FINAL REPORT

CONSTRUCTION QUALITY ASSURANCE (CQA)

FINAL REPORT
CONSTRUCTION QUALITY ASSURANCE (CQA)
ENVIRONMENTAL RESTORATION DISPOSAL FACILITY (ERDF)
SUPER CELLS 9 & 10
SUBCONTRACT S013213A00
010.032-00-ROB

SUPPLIER DEVIATION DISPOSITION REPORTS

Crest Pad Building Structural Plans and Sections

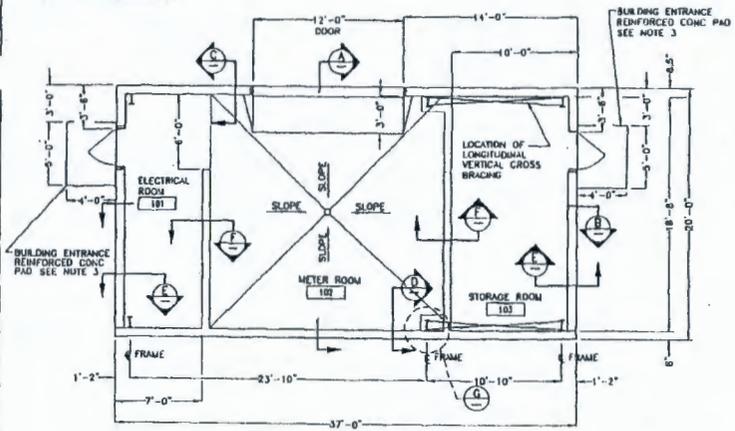
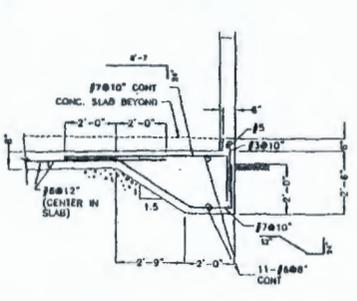
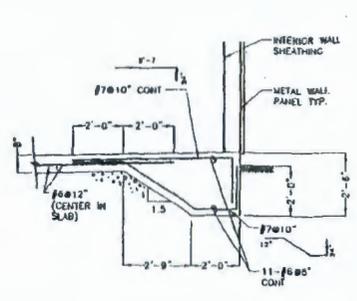
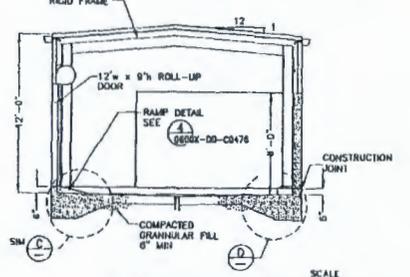
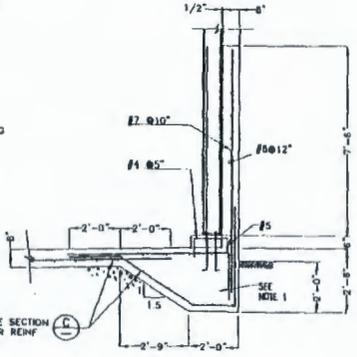
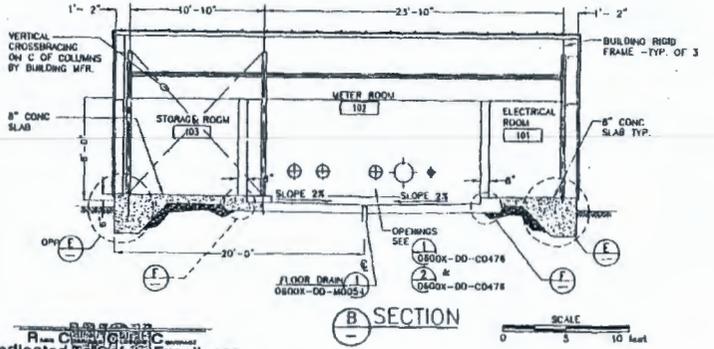
12. Deviation description:

- 1) Add #7 dowels 4'-6" @ 10" O.C.
- 2) Delete curb between footing and wall.

This eliminates two cold joints which could become a potential safety hazard. Also eliminates the need to extend 10' VTS bar out of the footing when the slab is poured. This would become an immediate safety hazard that would be eliminated. Secondary containment would be achieved by the existing 8' wall

Added value to WCH at no cost, no schedule change.

20. WCH Disposition Statement Including Justification (Attach extra sheets, sketches, etc., as necessary) <p style="font-family: cursive;">THE curb shall be part of monolithic slab to provide containment. The PROPOSED DEVIATION ADDS A JOINT AND DOES NOT PROVIDE CONTAINMENT</p>

1 SIDESLOPE LINER DETAIL
0600X-DD-C0458, C0459, C0460, C0462, C0463

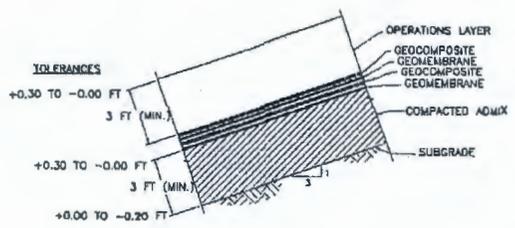
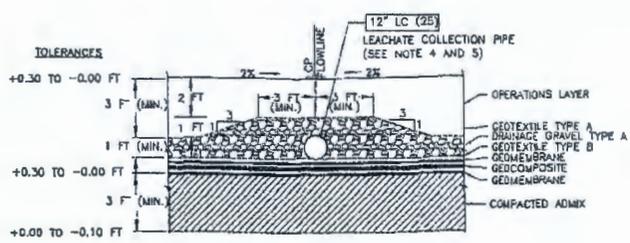
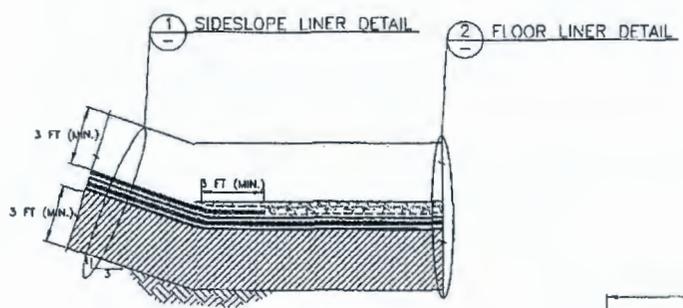
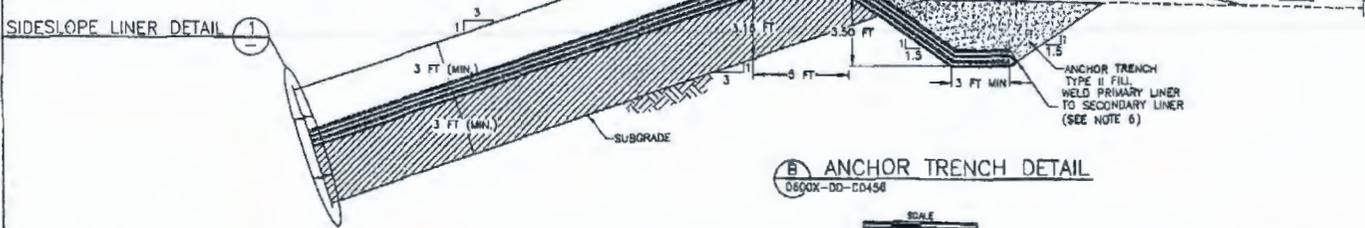
12. Deviation Description (Attach extra sheets, photographs, sketches, etc., as necessary and identify quantity and serial No.'s as applicable). Drawing 0600X-DD-C0458, Rev. 0, indicates a slope subgrade tolerance of +0.00 to -.020 feet.

WCH accepts the deviation and recommends the SUBBCONTRACTOR to "Use As-Is." WCH will allow the SUBCONTRACTOR to correct the deviation per their request by increasing the admix thickness to make up for localized low spots in the subgrade. It is determined that due to the limited size of the deviation and the independent oversight and certification provided by the Construction Quality Assurance (CQA) Subcontractor, that there would be no decrease in performance by placing the additional admix. For future similar occurrences, the CONTRACTOR maintains the right to apply the same logic in the resolution of questions concerning subgrade and admix tolerances.

Due to the unique circumstances causing the deviation, no changes to the design or specifications are required. The SUBCONTRACTOR is expected to build the remainder of the cell(s) to the tolerances shown in the design and specifications.
